## REMARKS

The Examiner has objected to the drawings in that Figs. 1-5 should be designated by a legend such as --Prior Art--.

**FIG. 1C**

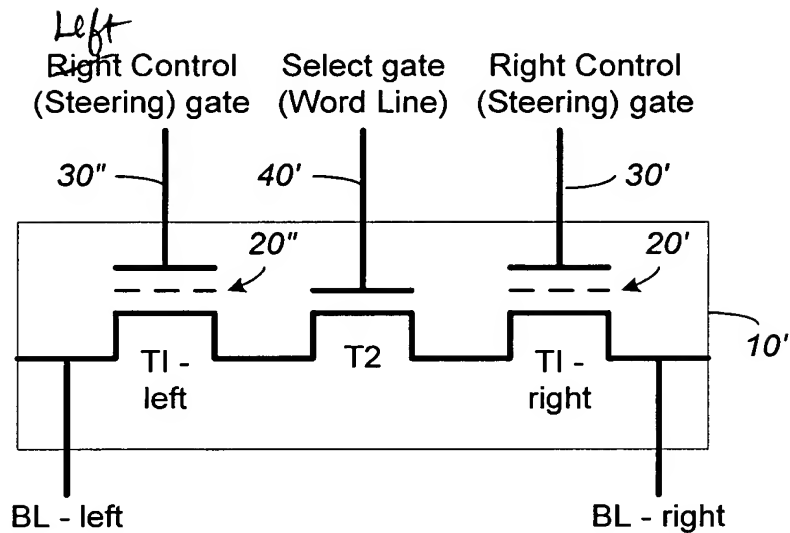
Figs. 1-5, are being amended as suggested by the Examiner by submission of seven sheets of revised drawings. Also in Fig. 1C, the label for the line designated by 30" is being changed to - -Left Control (Steering) gate- - in order to correct a typographical error.
